HISTORIC AND DESIGN REVIEW COMMISSION

HDRC CASE NO: 2018-624
ADDRESS: 322 W ELSMERE PLACE
LEGAL DESCRIPTION: NCB 3967 BLK 2 LOT 6
ZONING: R-5,H
CITY COUNCIL DIST.: 1
DISTRICT: Monte Vista Historic District
APPLICANT: Al Zgardowski
OWNER: Peter and Julie Nyren
TYPE OF WORK: Fenestration modifications, window replacement
APPLICATION RECEIVED: November 20, 2018
60-DAY REVIEW: January 19, 2018
REQUEST:

322 W ELSMERE PL
R.H. SIDE

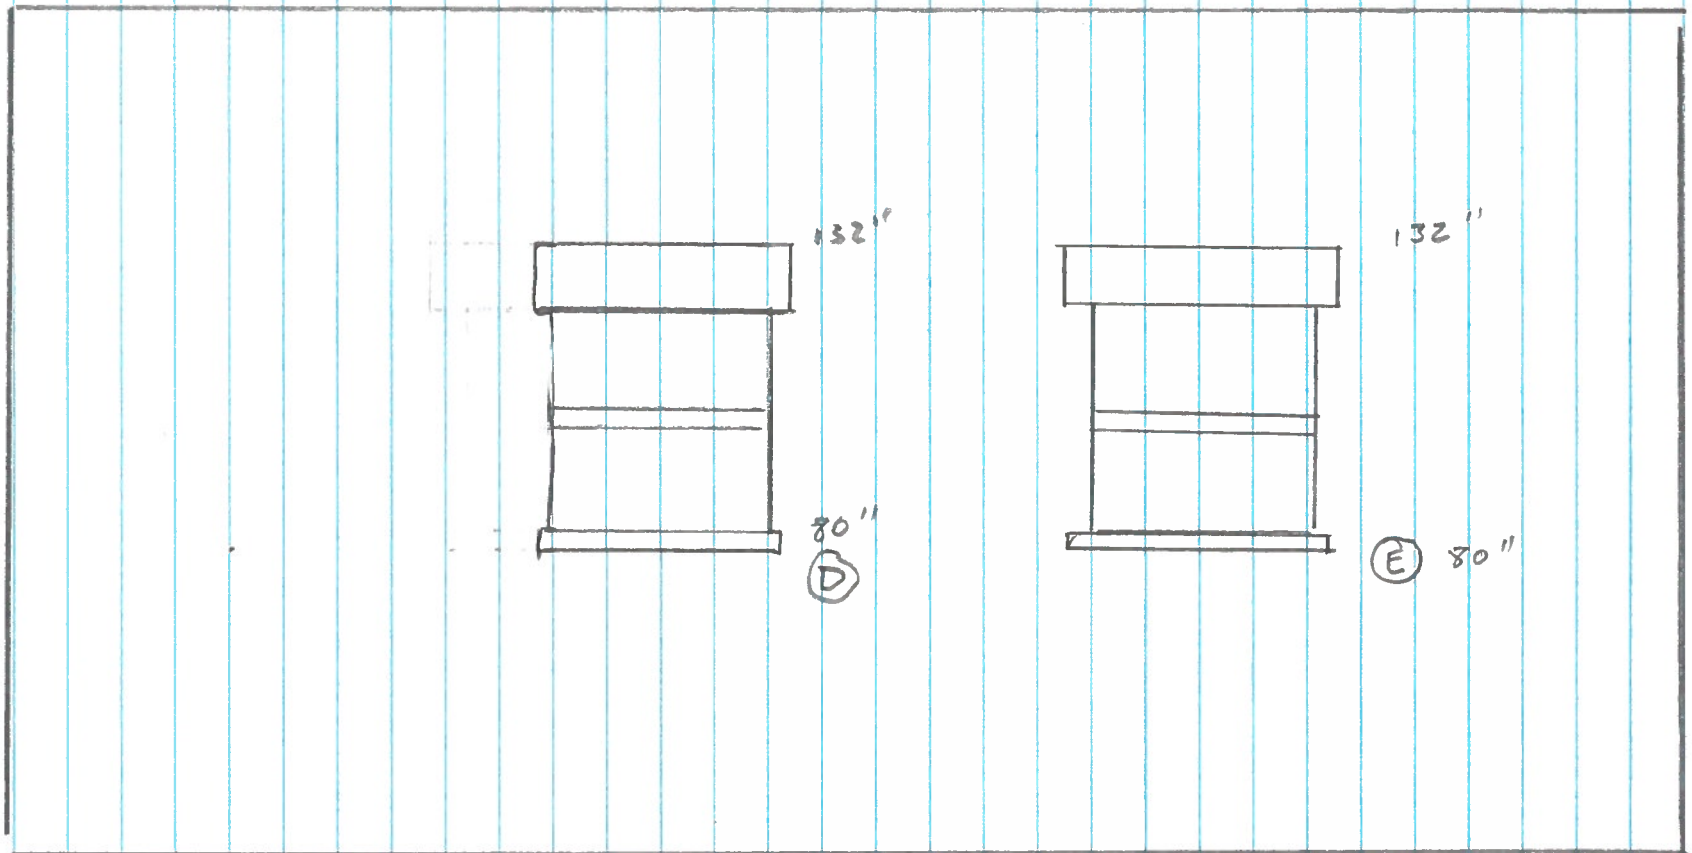
- b. WINDOW RELOCATION: EXISTING WOOD TO NON-ORIGINAL ALUMINUM – The applicant is requesting approval to relocate an existing one over one wood window on the structure to the location of an existing non-original aluminum window. The aluminum window will be removed and the opening will be modified to accommodate the new size. According to the Historic Design Guidelines, existing openings should be preserved. Non-original windows may be replaced with an appropriate replacement window. While staff finds that the aluminum window may be replaced, staff does not find the relocation of an existing wood window appropriate. Staff finds that the existing wood window should remain in place and be restored and an appropriate wood window should be installed in the aluminum window location.

- c. WINDOW REPLACEMENT WITH SLIDING DOOR – The applicant is requesting approval to replace two existing one over one wood windows with a new aluminum sliding door on the side façade. According to the Historic Design Guidelines, existing openings should be preserved. Staff does not find the request consistent with the Guidelines.

ITEM A R/R ALUM. SLIDER
WITH ORIG. WOOD
WINDOW

ITEM B
R/R TWO
WINDOWS
WITH
DBL SLIDER

Item 1, Staff does not recommend approval of the window relocation based on finding b. Staff recommends that the existing wood window and opening remain and that the existing wood window be rehabilitated. Staff recommends replacement of the non-original aluminum window with a new wood window with the following stipulation:

- i. That the window features meeting rails that are no taller than 1.25” and stiles no wider than 2.25”. There should be a minimum of two inches in depth between the front face of the window trim and the front face of the top window sash. Window track components must be painted to match the window trim or concealed by a wood window screen set within the opening.

Item 2, Staff does not recommend approval of the replacement of two original one over one wood windows with a sliding aluminum door based on finding c.

322 W ELSMERE
L.H. SIDE

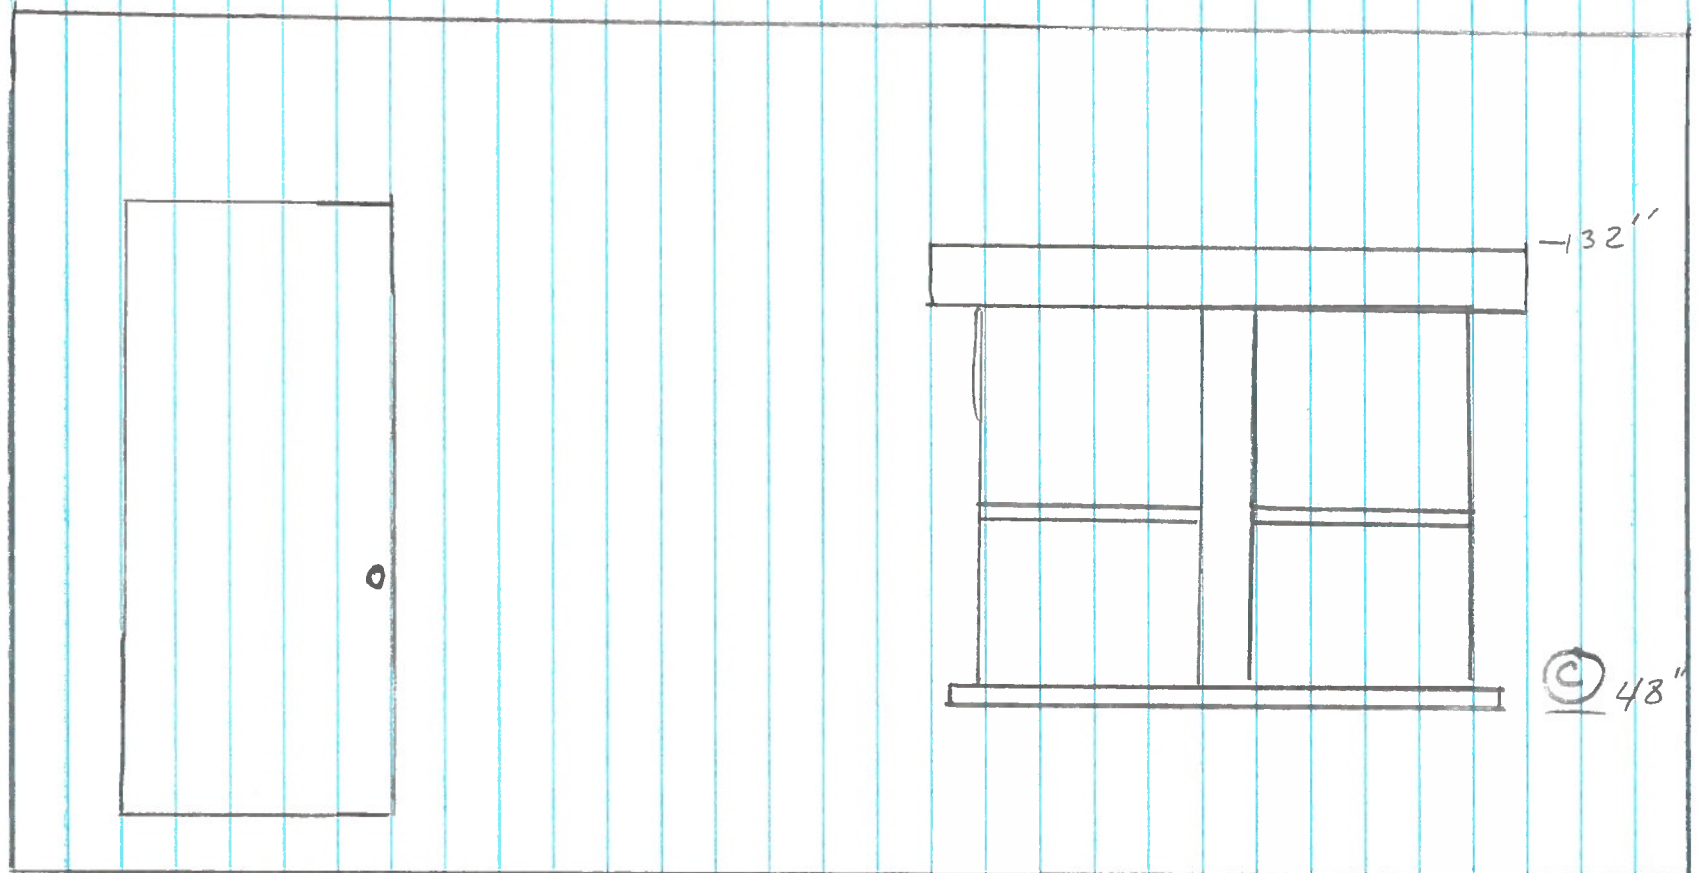
- d. WINDOW ENCLOSURE – The applicant is requesting approval to enclose an existing wood window opening on the left façade with siding. According to the Historic Design Guidelines, existing openings should be preserved.

- a. WINDOW MODIFICATION – The applicant has proposed to remove an existing one over one wood window and modify the opening. The sill height will be raised per the submitted documentation. According to the Historic Design Guidelines, existing window and door openings should be preserved. Wood windows should only be replaced if they are determined to be deteriorated beyond repair. Enlarging or diminishing existing openings to accommodate new windows or stock sizes should be avoided. While staff finds that the existing windows requested to be replaced are deteriorated beyond repair and eligible for replacement, staff does not find the proposed opening modifications to be appropriate. Staff finds that the existing opening should be retained the window be restored.

ITEM D CLOSE L.S. WINDOW
MODIFY R.S. WINDOW
TO MATCH ITEM E

ITEM E RESTORE EXISTING
WINDOW/SIDING

Item 3, Staff does not recommend approval of the window enclosure based on finding d.

Item 4, Staff does not recommend approval of the window opening modification based on finding e. Staff recommends that the window size be retained and the existing window be restored.

322 W. ELSMERE PL
Rear View

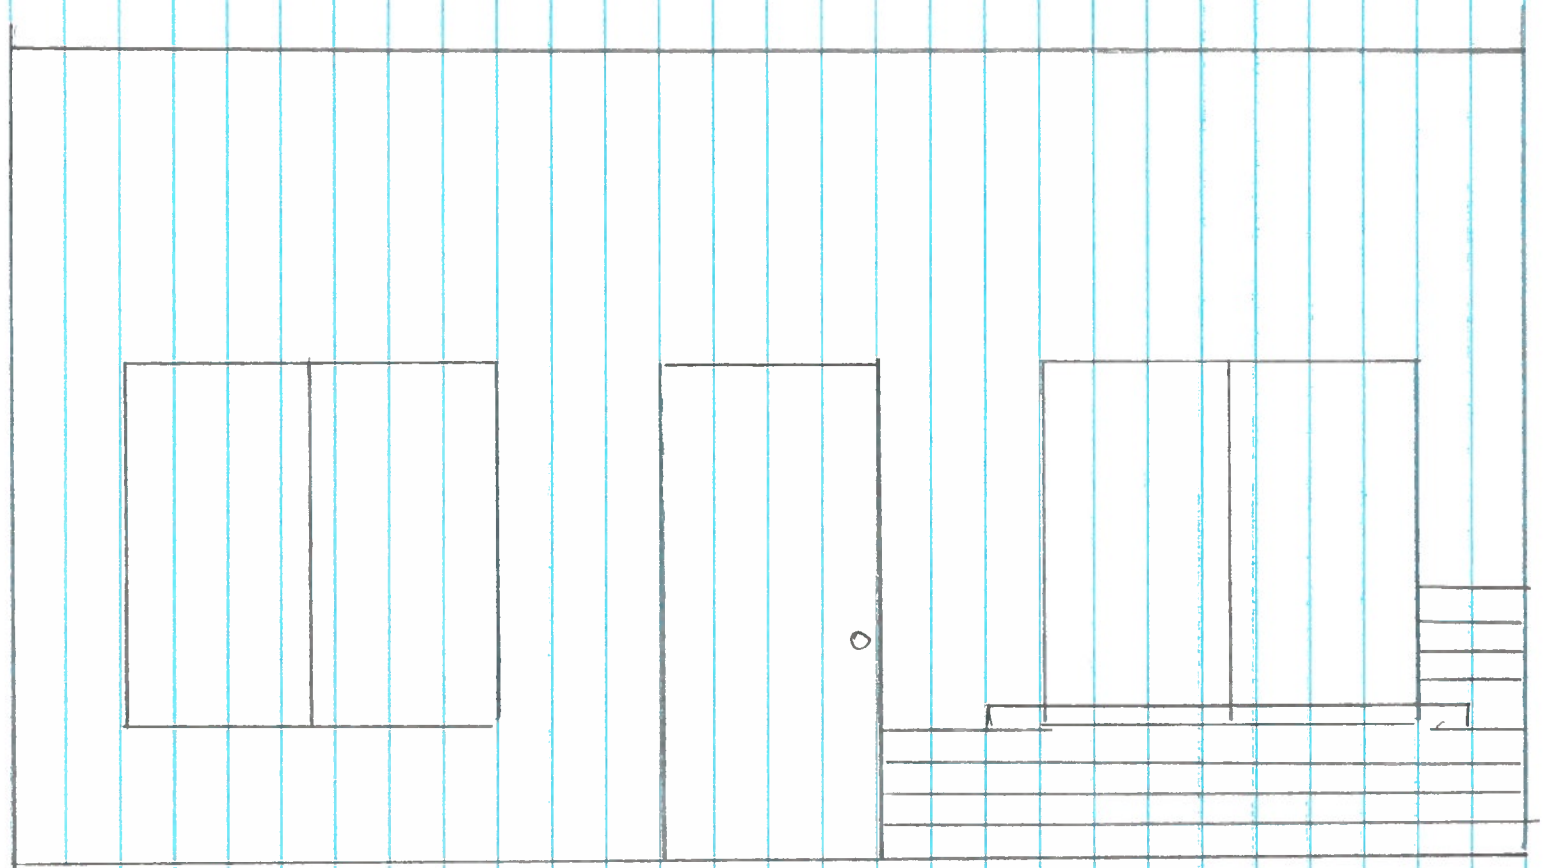
- e. STEEL DOOR REMOVAL AND WINDOW RELOCATION – The applicant is requesting approval to remove an existing non-original steel door and relocate the existing windows that flank the door to infill the door opening. According to the Historic Design Guidelines, existing openings should be preserved. While staff finds that the existing non-original door may be replaced, staff does not find the relocation of the wood windows to be appropriate. Staff finds that a compatible replacement wood door or a new wood window to match the existing in a ganged configuration would be appropriate.

ITEM C R/R STEEL DOOR
& MOVE 2 ORIG. WOOD
WINDOWS TOGETHER

Item 5, Staff does not recommend the relocation of the wood windows based on finding e. Staff finds that a compatible replacement wood door or a new wood window to match the existing in a ganged configuration would be appropriate. The replacement of the existing door with a wood door is eligible for administrative approval. If a new window is to be installed in this location, updated drawings are required to be submitted to staff for review and approval. A new window must create a true ganged condition to be appropriate.
